Terrence Fleming
U.S. Environmental Protection Agency Region 9, WTR-2
75 Hawthorne Street, San Francisco, CA 94105
Fax: (415) 947-3537

February 11, 2003

RE: Comments on the draft Total Maximum Daily Loads for Nutrients, Malibu Creek Watershed

Heal the Bay Comments on the Draft Nutrient TMDL for the Malibu Creek Watershed
February 11, 2003. Figure 1. Map of Heal the Bay sampling sites.

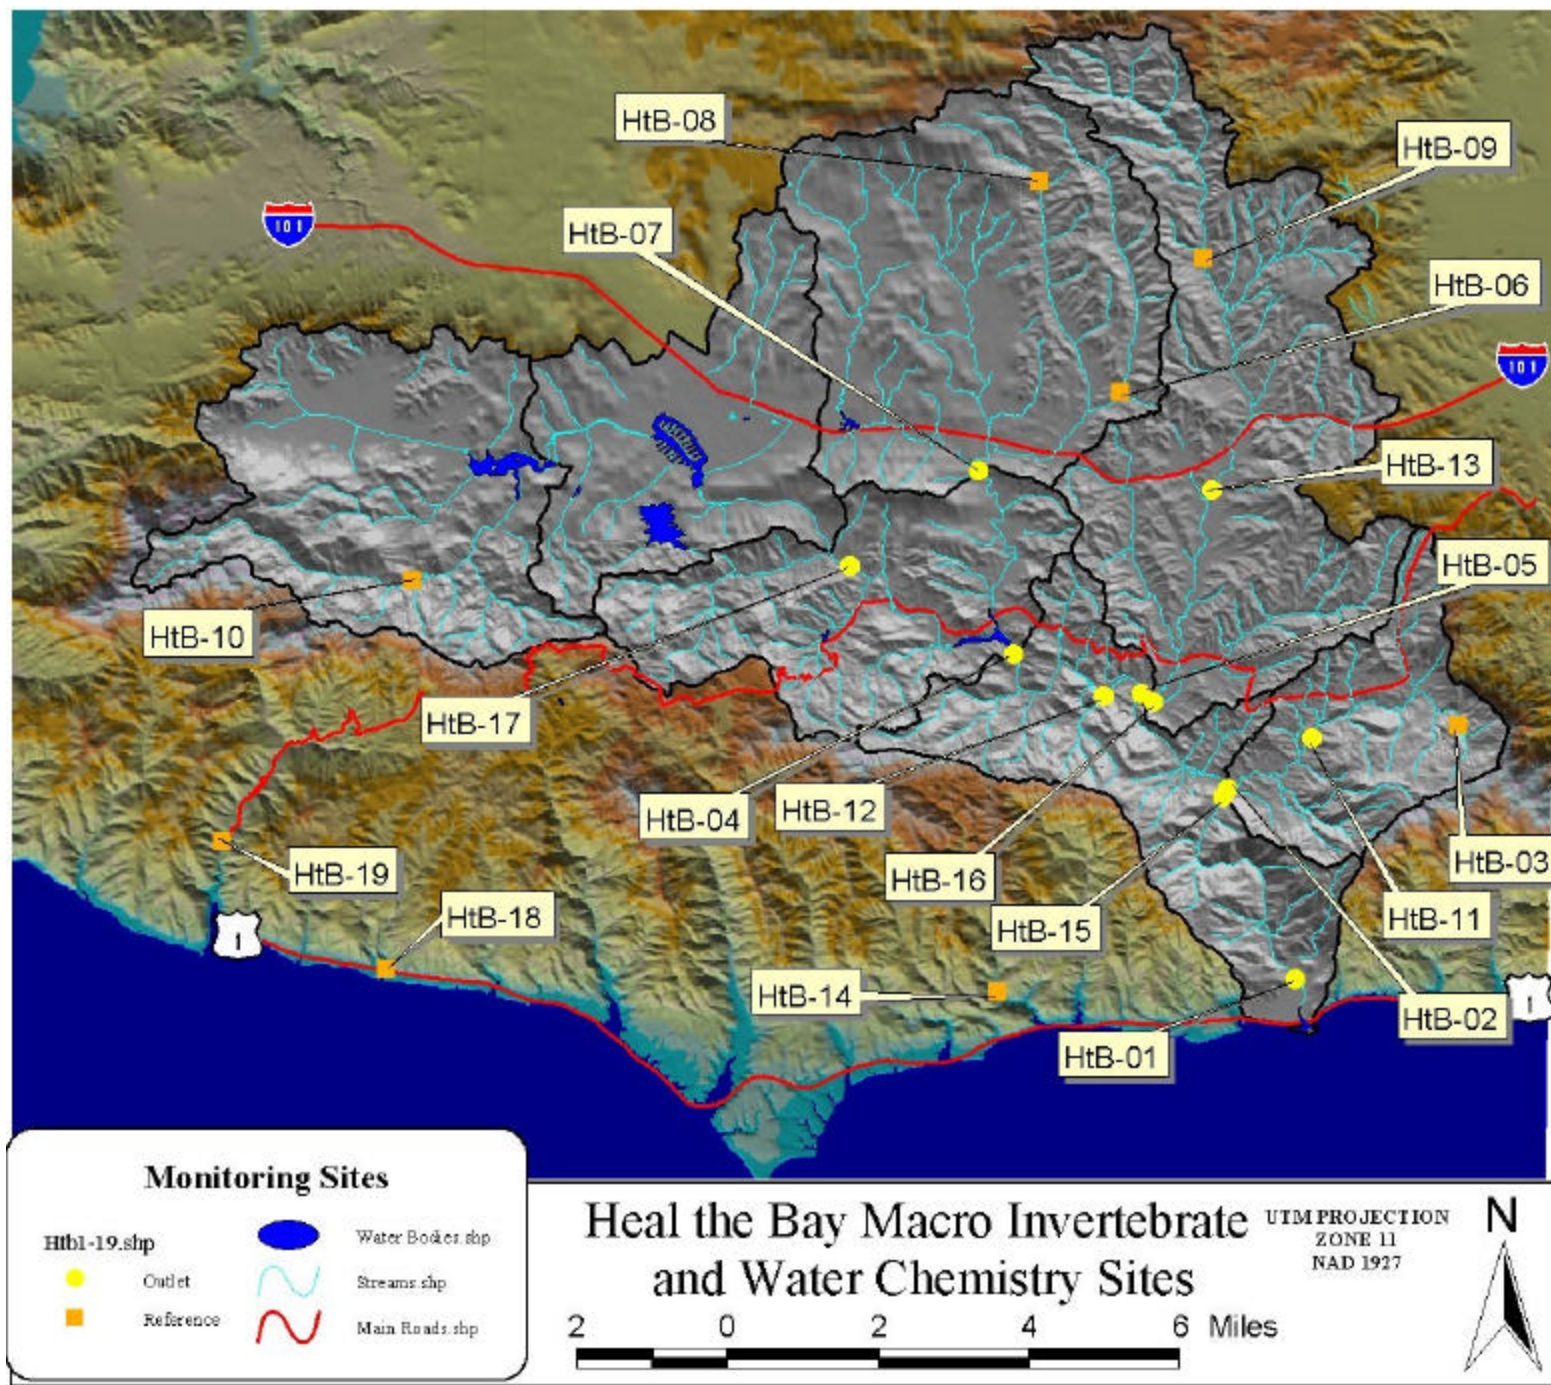
In contrast, Heal the Bay has objectively selected several reference locations to assist in establishing reference conditions for TMDL development (Figure 1). Heal the Bay's reference sites were selected based on upstream land use and lack of anthropogenic influences (Table 1). Reference sites 3, 8, 10, 14 and 18 drain open space and have virtually no upstream land uses that would impact nutrient loadings to the creek.

Reference sites 6 and 9 also drain open space and may be influenced only by the Lost Hills landfill. These seven reference sites provide the best possible indication of true background levels of nutrients and algae in the watershed, and at similar sites just outside the watershed (i.e. site 14 which is in lower Solstice Creek, and site 18 which is in lower Lachusa Creek).

EPA Response: We have no problem with the location of the reference stations defined by Heal the Bay. Unfortunately we have difficulty interpreting the Heal the Bay numbers for nitrogen because they measured nitrate rather than total nitrogen. The TMDL targets for the summer are based on total nitrogen. A comparison of the nitrate numbers indicates that the values found by Heal the Bay are comparable to those found upstream of Tapia and at the SCCWRP reference stations. The phosphate data presented by Heal the Bay and by Tapia also seems high relative to other parts of the country and high relative to values presented by SCCWRP. This may indicate methodological problems.

Figure 2. Average dry season nitrate-nitrite-N concentrations in Malibu Creek watershed.

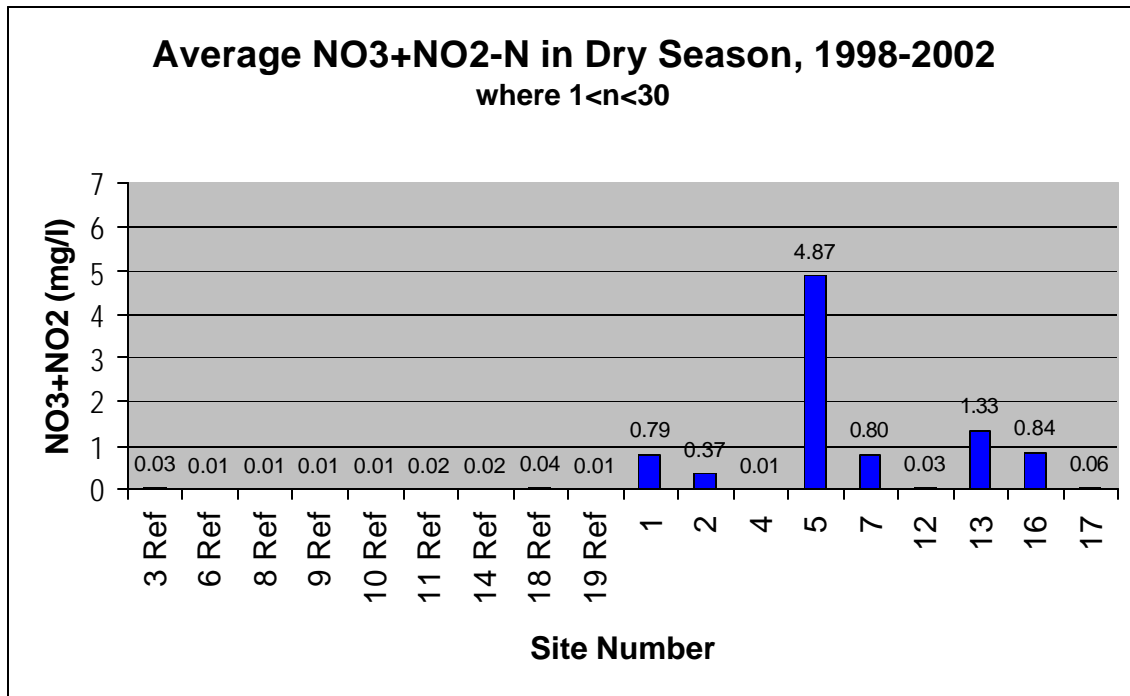
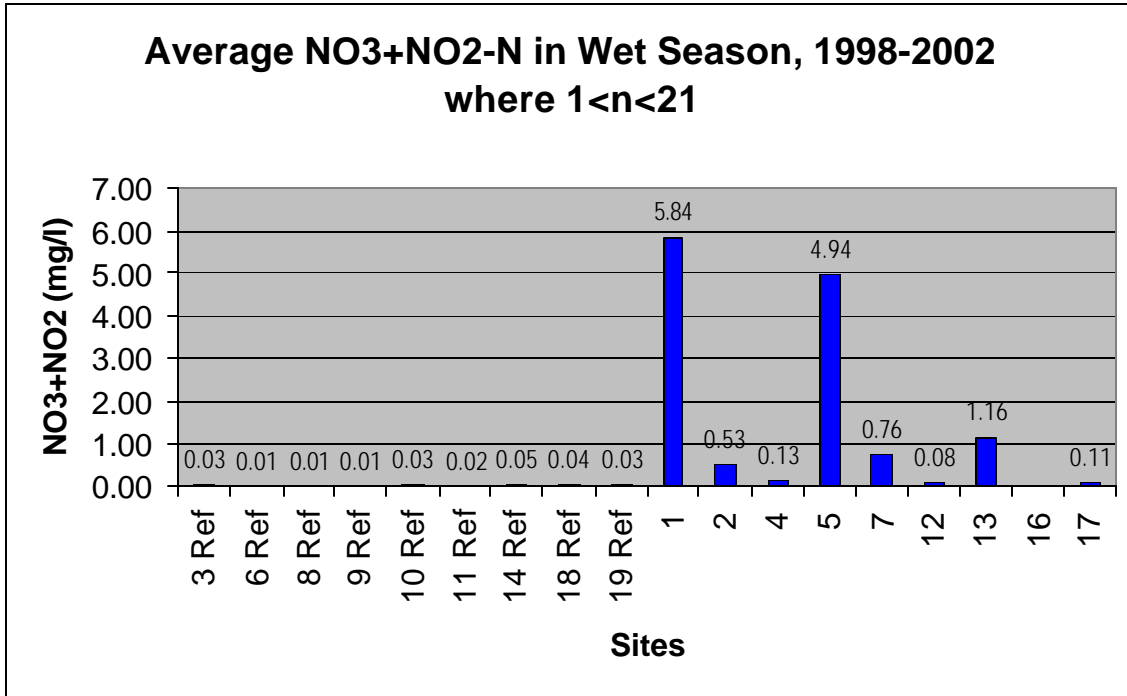
Heal the Bay's reference sites clearly show that the background nitrate+nitrite-N concentration in the watershed is less than about 0.05 mg/l in both wet and dry seasons (Figs. 2 and 3). The average background nitrate+nitrite-N concentration is **0.02 mg/l** in the dry season, and **0.03 mg/l** in the wet season. The only sites that regularly exceed 1.0 mg/l nitrate+nitrite-N in the wet season are Site 1, downstream of Tapia's main discharge; Site 5, downstream of Tapia's Rancho Composting facility; and Site 13, downstream of Tapia's discharge 002 (Tapia's site R6). Only site 1 (Cross Creek Road in Malibu Creek), site 2 (outlet of Cold Creek draining Montenido) and site 13 (Las Virgenes Creek at Lost Hills Road) exceed the proposed TMDL limit of 1.0 mg/l nitrogen. These sites are all highly impacted sites, and all show year-round algal impairment. For nutrient summary statistics see attached Table 5.

EPA Response: *As discussed previously, one of the issues confounding comparison between the HTB data and EPA targets is that the HTB data is based on NO₃+NO₂ while the EPA TMDL is based on total nitrogen (which also includes nitrogen species such as organic nitrogen and ammonia). The HTB data also included ammonia in the data set. These added marginally to the magnitude of the HTB numbers but did not radically change the pattern. More significant however is the lack of organic nitrogen data. Organic nitrogen may make up a significant component of the total available nitrogen. We compared the HTB data to data collected by UCSB in the Malibu Creek watershed. The nitrate values are low and comparable to the HTB values but the total nitrogen values are much higher. TN values from reference sites in Cold Creek and Palo Comado Creek were 225 times and 50 times higher than the nitrate values. These methodological differences make it difficult or impossible to compare the HTB numbers to the numbers developed in the TMDL. For this reason, no changes in the numeric target values are warranted.*

Figure 4. Average dry season phosphate concentrations in Malibu Creek watershed.

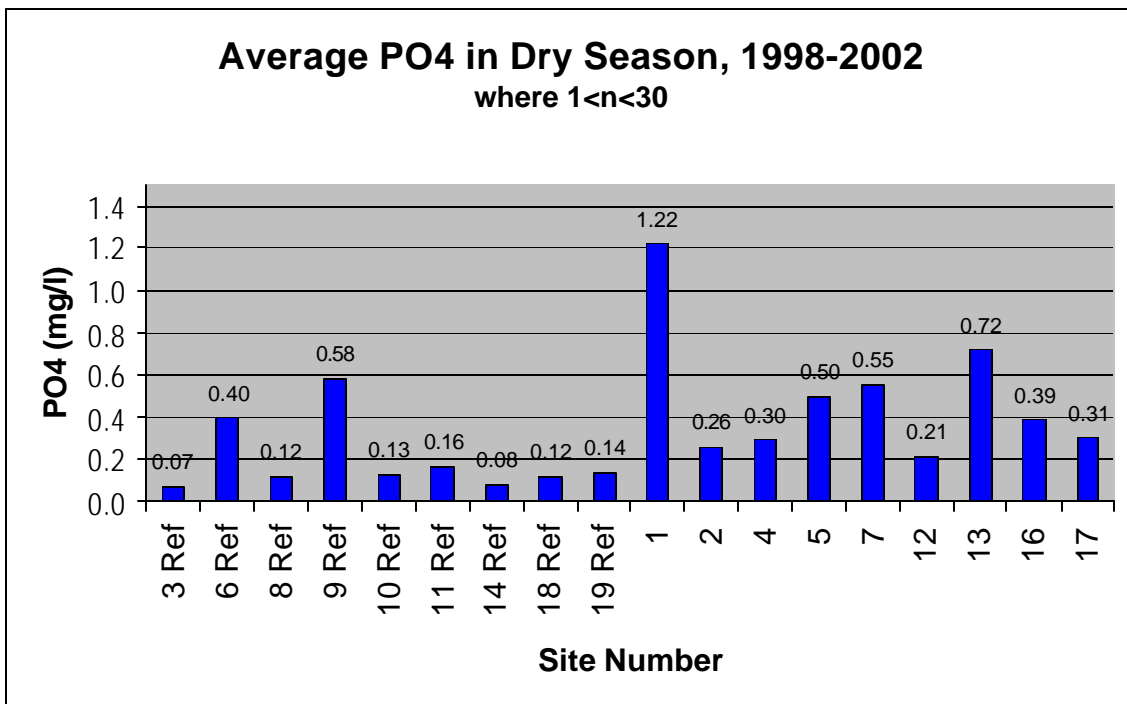
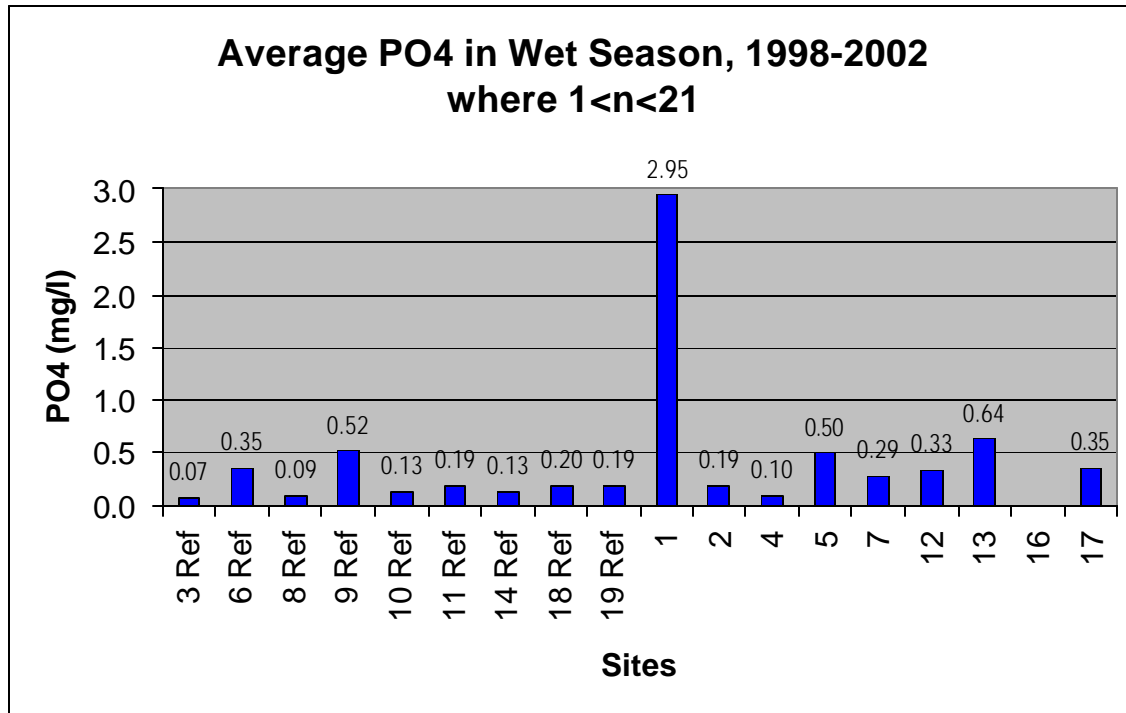
Heal the Bay's reference sites clearly show that the background phosphate concentration in the watershed is about 0.1 mg/l in both wet and dry seasons (Figs. 4 and 5). The average concentration in the dry season, excluding reference sites 6 and 9, is **0.12 mg/l**. The average concentration in the wet season, excluding sites 6 and 9, is **0.14 mg/l**.

EPA Response: *The HTB values for phosphate are consistent with the ambient data collected by Tapia. We note that these numbers are high compared to other parts of the country. These numbers also appear to be much higher than those measured by UCSB. This may indicate additional methodological issues that need to be resolved.*

Figure 8. Benthic algal/diatom and canopy cover in the wet season (Nov. 15-Apr.14). Canopy data were not available for sites 4, 8 or 10. See Table 1, Attachment 1 for data.

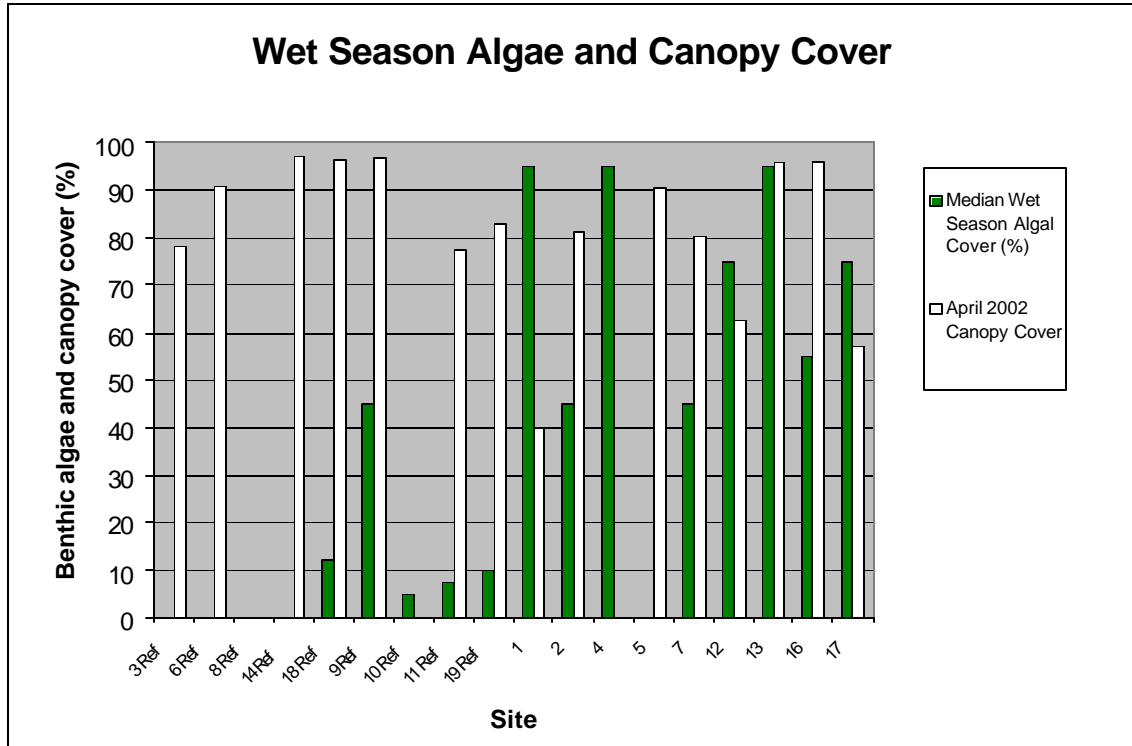
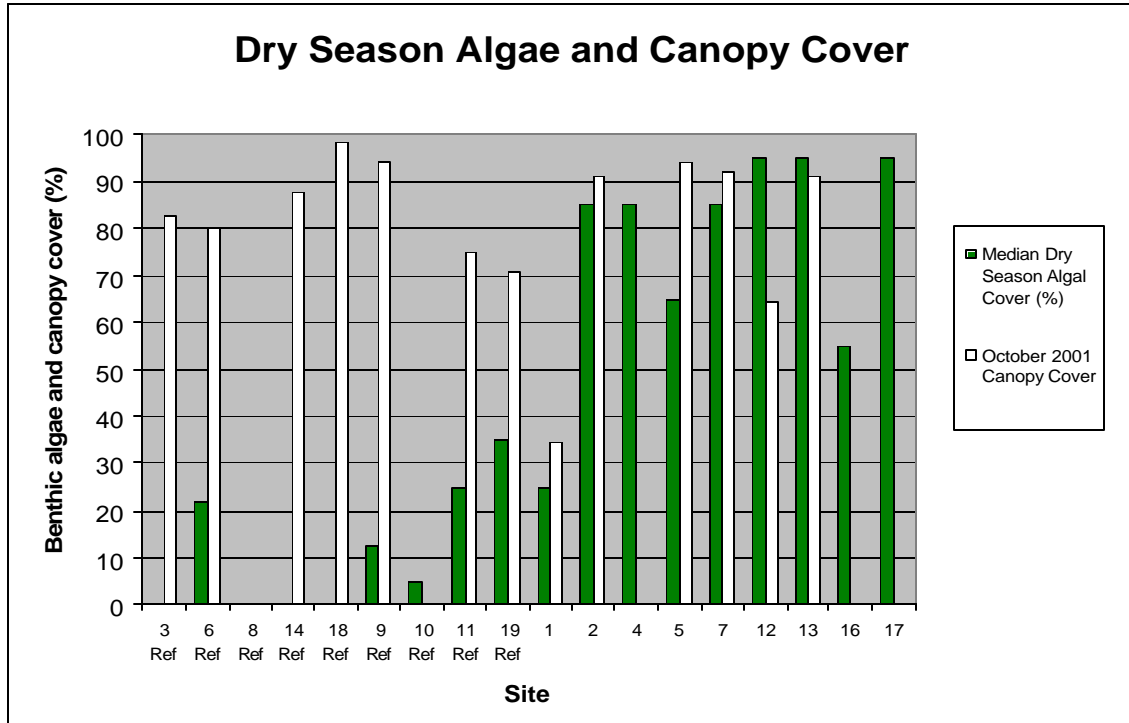
Figures 8 and 9 show that canopy cover does not affect algal cover. Canopy cover is high at most of our monitoring sites, while algal cover is only high at the impacted sites. The presence of canopy does not inhibit algal growth where nutrients are high. Benthic algal/diatom cover is substantially higher at impacted sites than at the reference sites. Nutrients are also generally higher at the impacted sites.

EPA Response: *The data in Figs. 8 and 9 suggest no relationship between canopy and algal cover. However, the data provided by Tapia and summarized in the CH2MHill report suggest a clear connection. Again this underlies the uncertainty in our understanding of the factors controlling algae and suggests that additional research is desirable.*
